COLLEGE OF ENGINEERING CAMPUS MASTER PLAN AMENDMENT JOINT CAMPUS AREA COMMITTEE

December 12, 2023

PROPOSED AMENDMENTS

DRIVERS AND PEDESTRIAN CIRCULATION

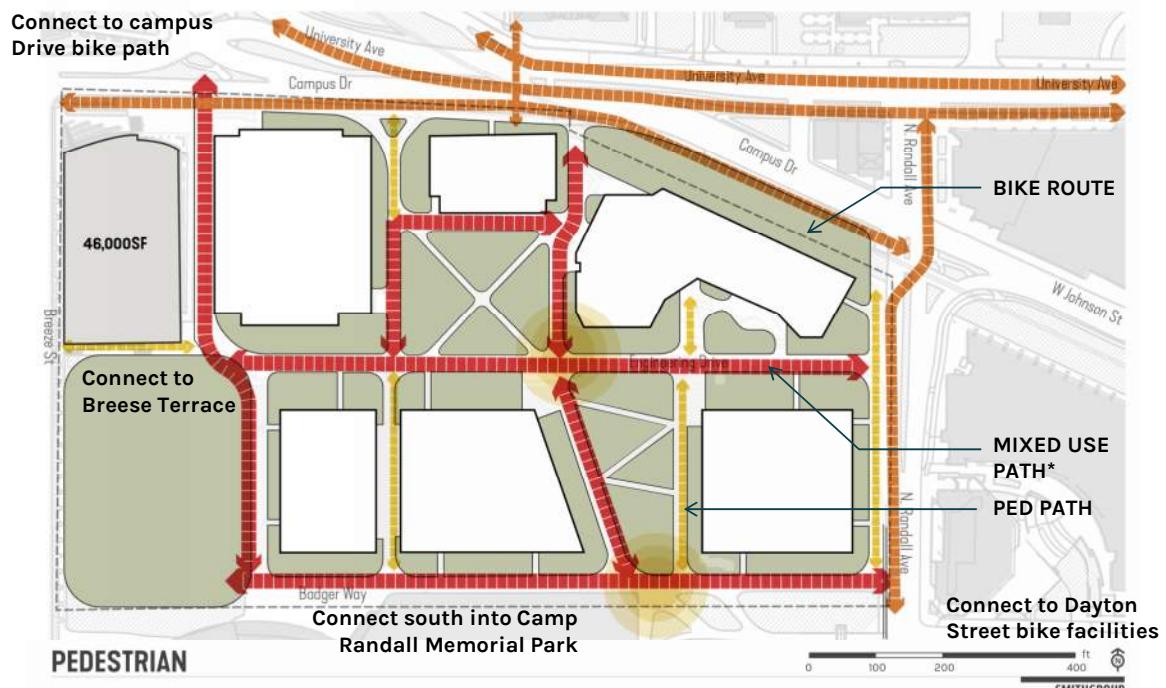
The Engineering Drive Corridor is the primary pedestrian route. The plan modifies the north / south connection to create a link to Camp Randall Memorial Park to the south and corresponds with a potential entry to the McClain Center (Camp Randall Sports Center Redevelopment)

*Mixed Use Paths to accommodate service and emergency vehicles

DRIVERS AND VEHICLE CIRCULATION

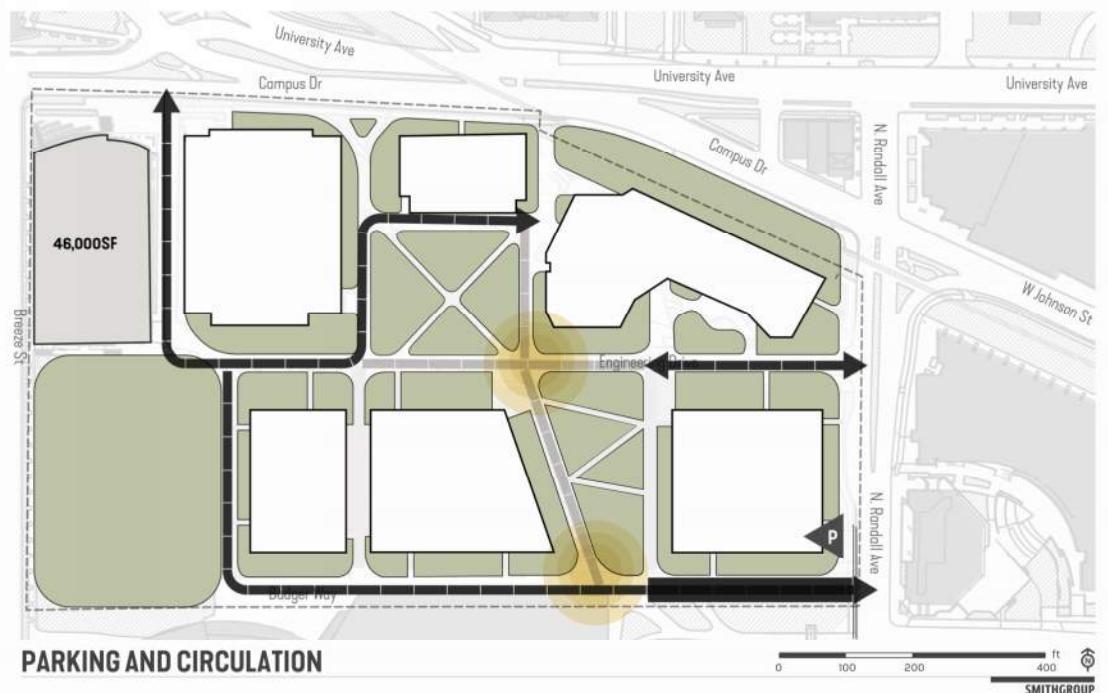
The multi-use paths enable circulation for service and emergency vehicles to distribute service and reduce conflicts at the interior of the site. Parking and delivery could potentially be located at the SE corner to ease distribution

DRIVERS AND SENSE OF PLACE

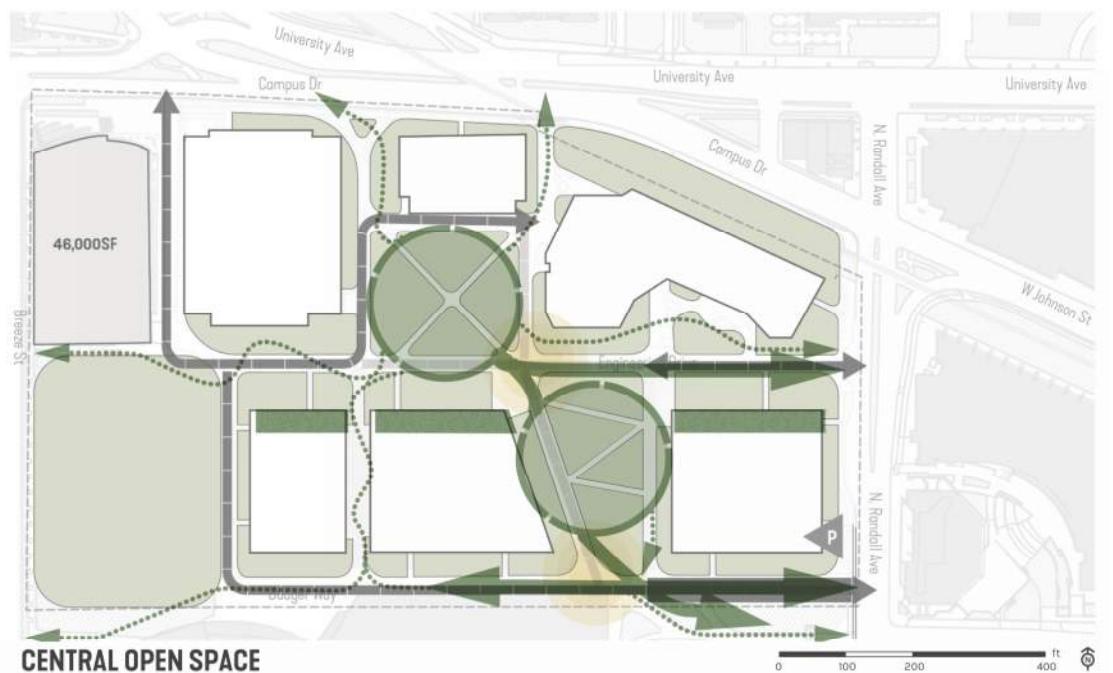
Two spaces form a modern interpretation of a quad. The southeastern space may also become a stormwater feature that highlights civil engineering

STORM WATER MANAGEMENT

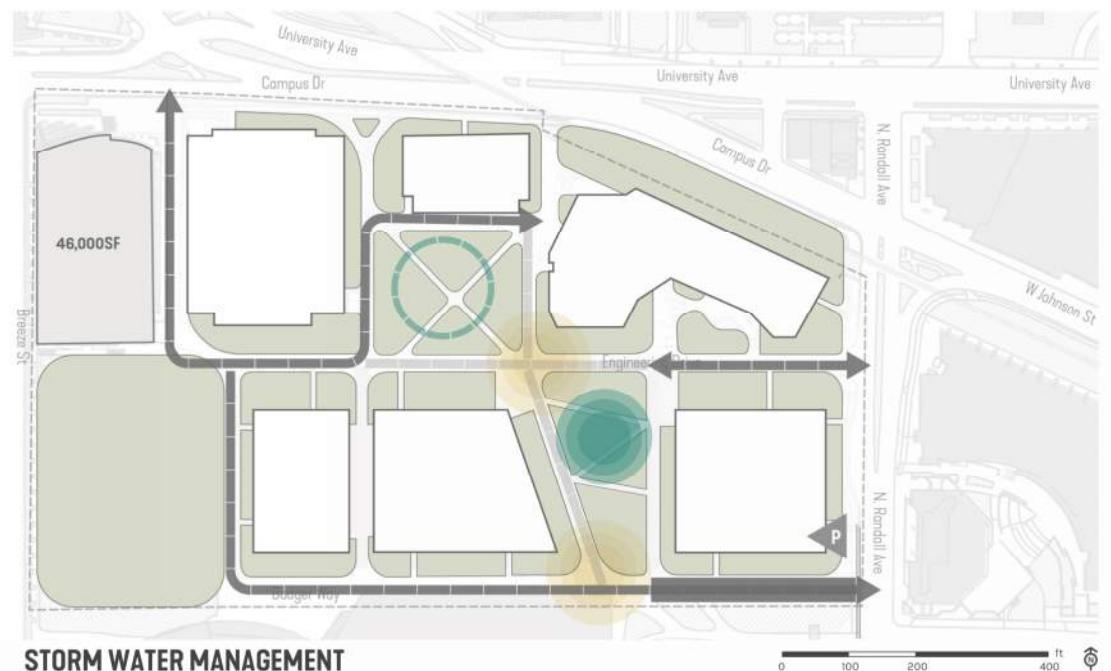
The corridors at Engineering Drive and to the south are wider to provide more space for site features, landscaping, bike parking and opening up the space .
Stormwater should be incorporated as both subsurface storage, a feature stormwater garden and with green or blue roofs throughout

UTILITIES: STORM WATER, STEAM, ELECTRIC, CHILLED WATER DURING 2023 COE DESIGN

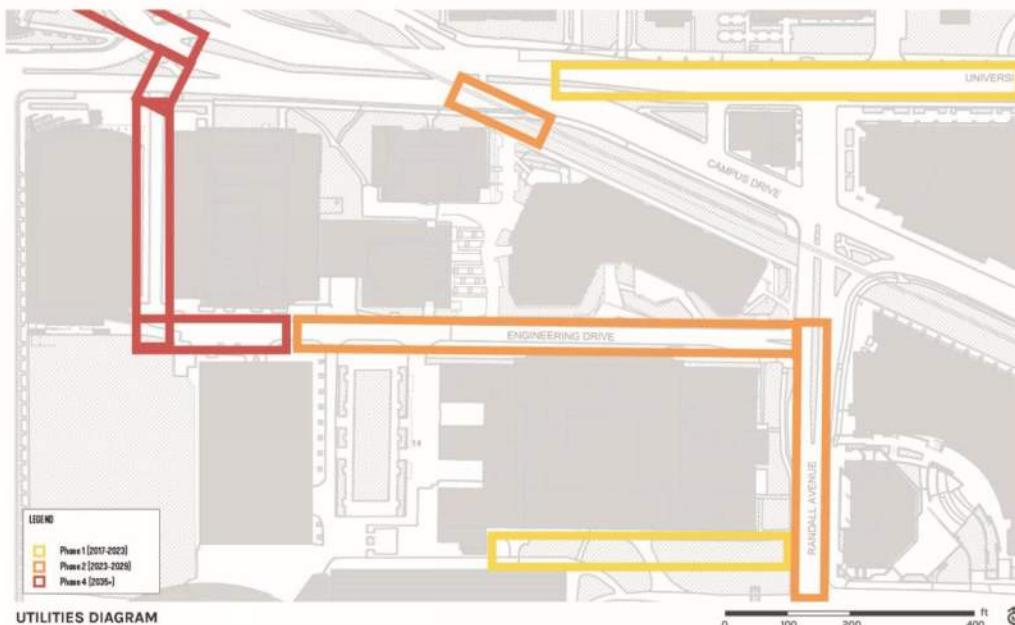
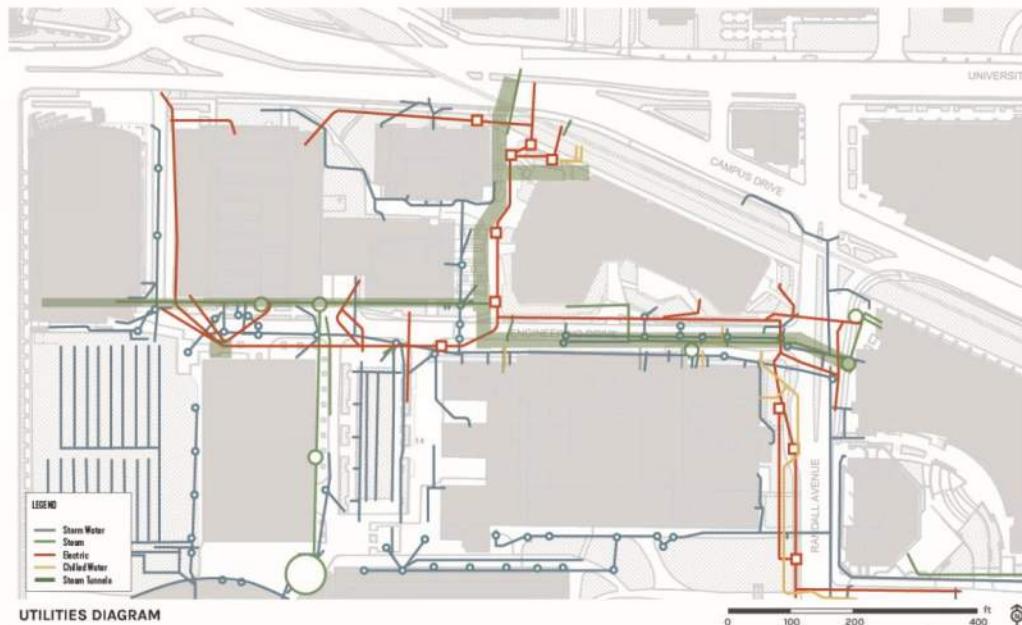
Note: The steam and chilled water lines currently east of the parking structure are radial feeds serving the Athletic Complex south of this area. They can be relocated but will need to maintain services.

The other lines between Engineering Drive and Athletics are local and can be moved as needed.

FIGURE GROUND COMPARISON

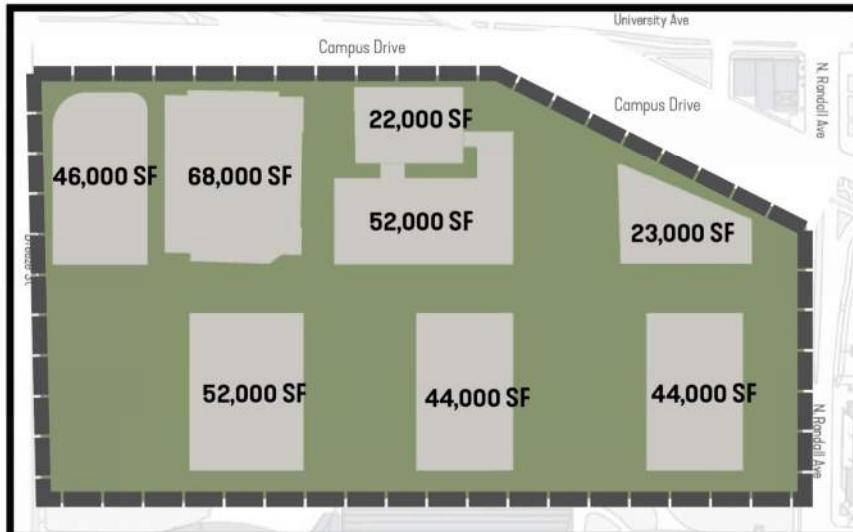
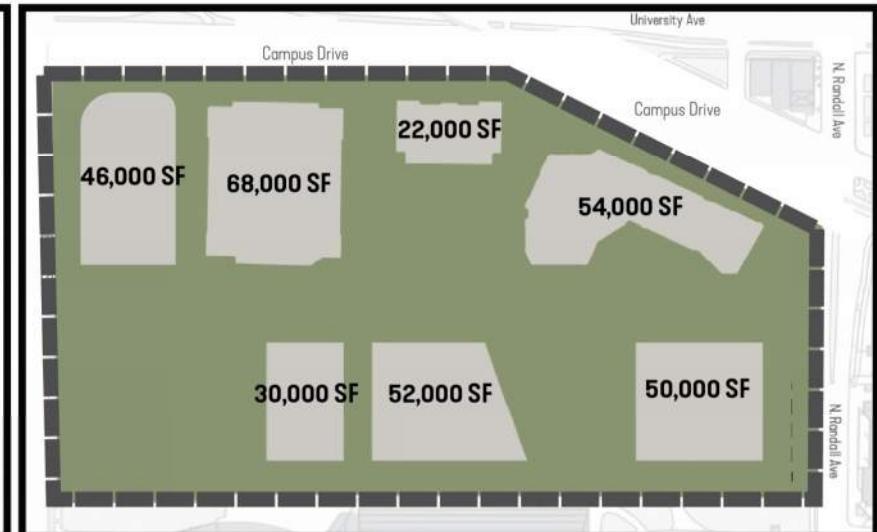
OVERAL AREA: 878,000SF

BUILDING FOOTPRINT: 351,000SF
60% OPEN SPACE

OVERAL AREA: 878,000SF

BUILDING FOOTPRINT: 322,000SF
63% OPEN SPACE

GSF AND FAR COMPARISON

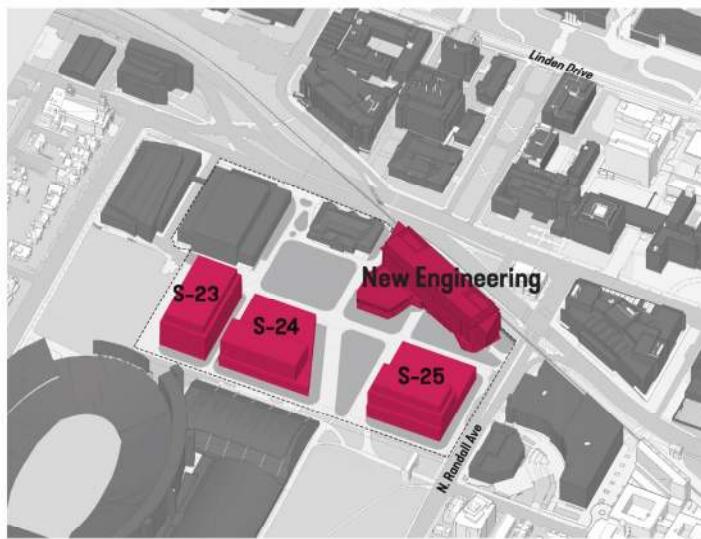
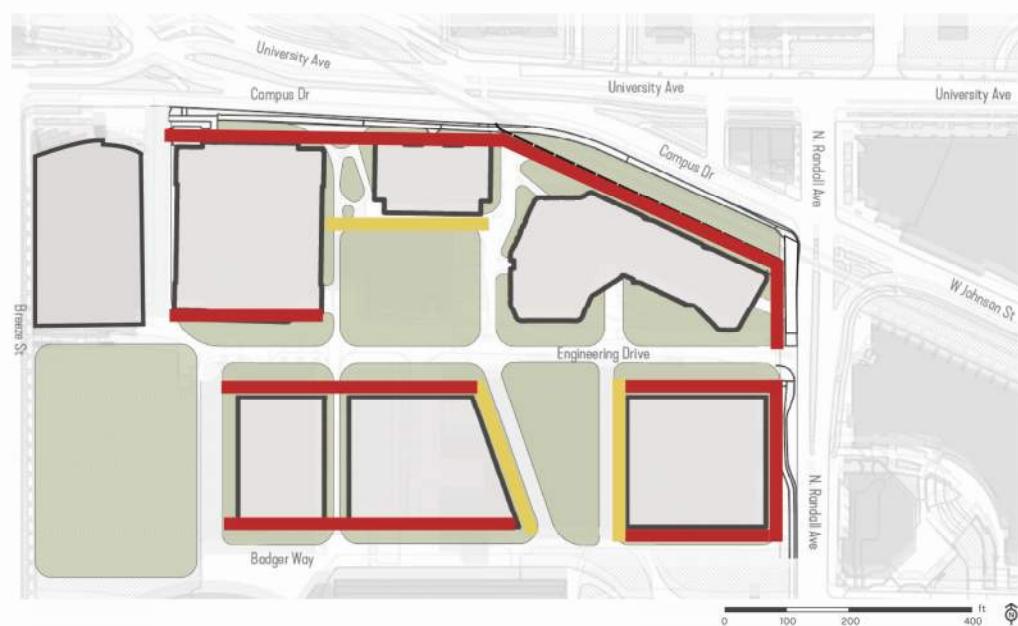
S-01+02: 441,000
S-23: 204,000
S-24: 237,000
S-25: 170,000

OVERALL: 1,052,000GSF

New Engineering: 385,000GSF
S-23: 228,000GSF
S-24: 196,000GSF
S-25: 248,000GSF

OVERALL: 1,057,000GSF

SOUTH CAMPUS PROPOSED
Total Building GSF: **9,587,435**
Total District GSF: 6,687,740
Floor Area Ratio: 1.43
